**MEMORANDUM**

**RE:** Technical Review from Dan Burden, Walkability Consultant

## Re: Northville Downs Technical Memorandum (01-25-22)

Figure 1: Downs Preliminary Site Plan (1-20-22)

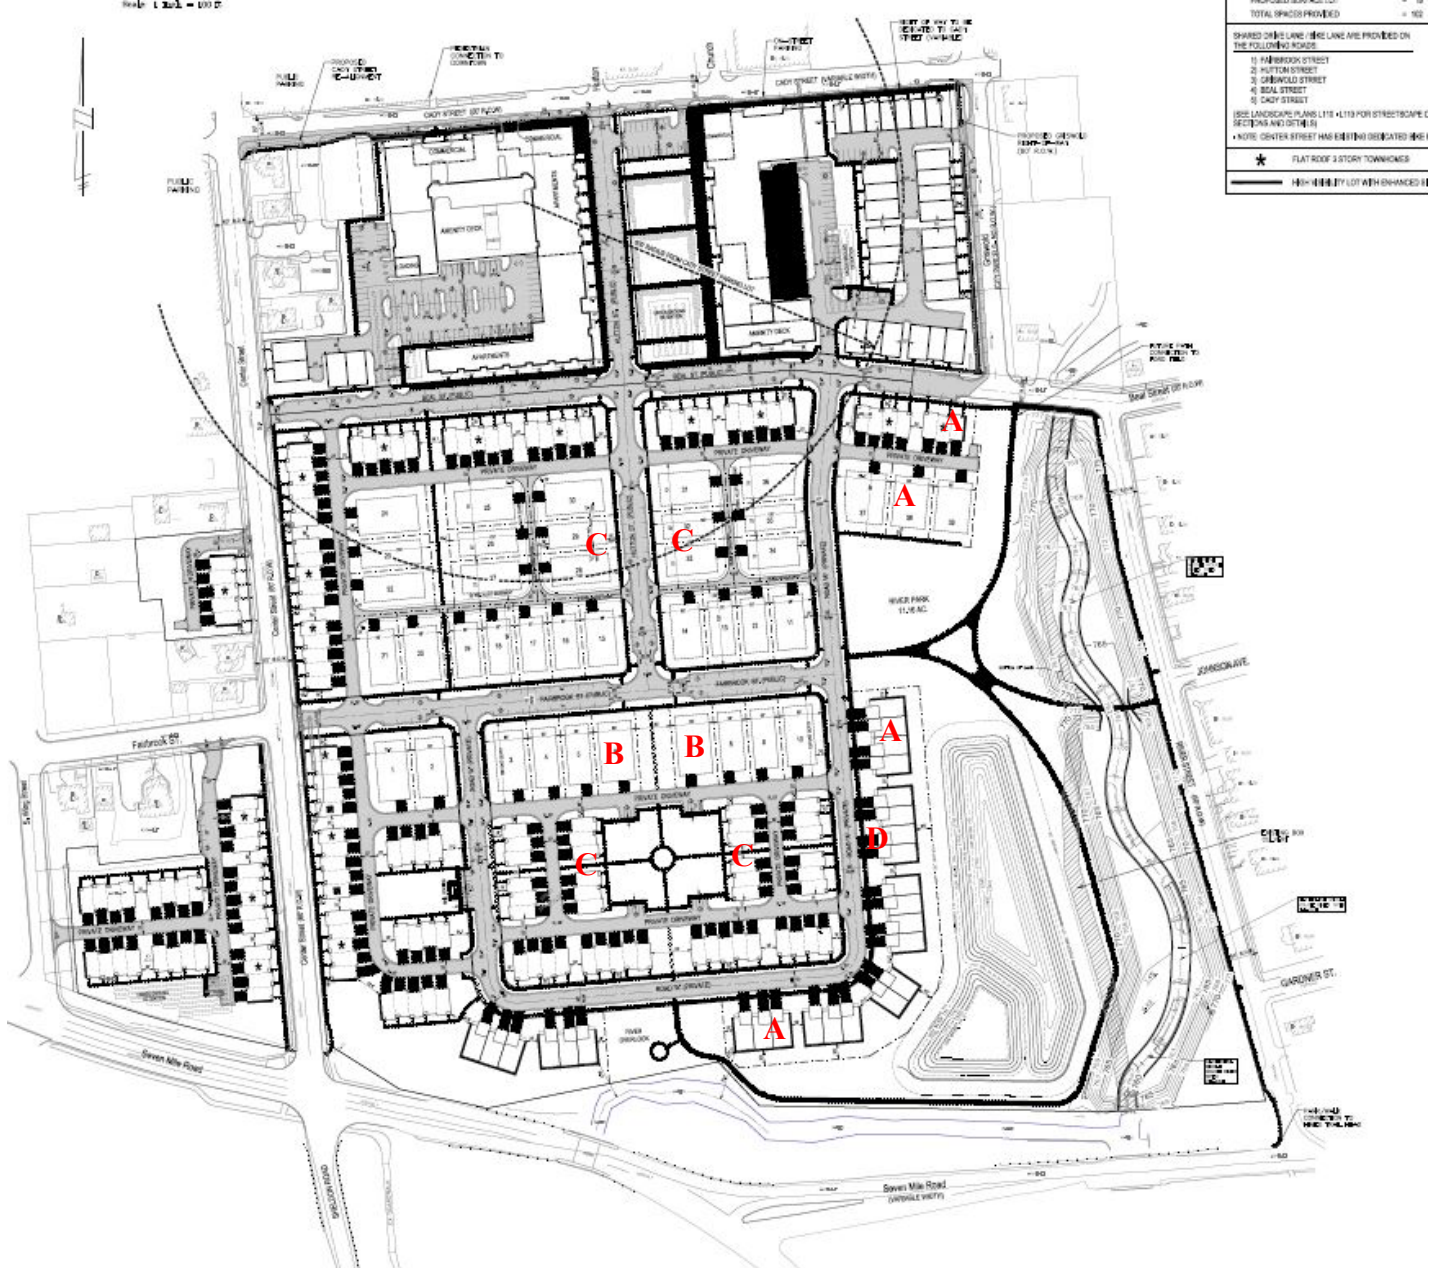
**D. Burden Comment 2:** *No evidence of increased “eyes on the trail” or other public spaces is evident.*

Clarification: This comment refers to orienting homes so that the front of the buildings overlooks open space, providing opportunities to keep an eye on activities in the open space. Locations of additional opportunities are identified as “A” on the Site Plan image below.

**D. Burden Comment 3:** *Missed opportunity for building orientation to watch over the Hutton Street open space connector.*

Clarification: Location identified as “B” on the Site Plan image below.

**D. Burden Comment 4:** *No further density was added in key locations such as open spaces and no open space perimeter trail or road was added.*

Clarification: Location of additional opportunities for higher density identified as “C” on the Site Plan image below.

**D. Burden Comment 6.** Missed opportunity to provide a direct open space connector to the waterfront (by rearranging one housing cluster).

Clarification: Location of additional opportunities for higher density identified as "D" on the Site Plan image below.
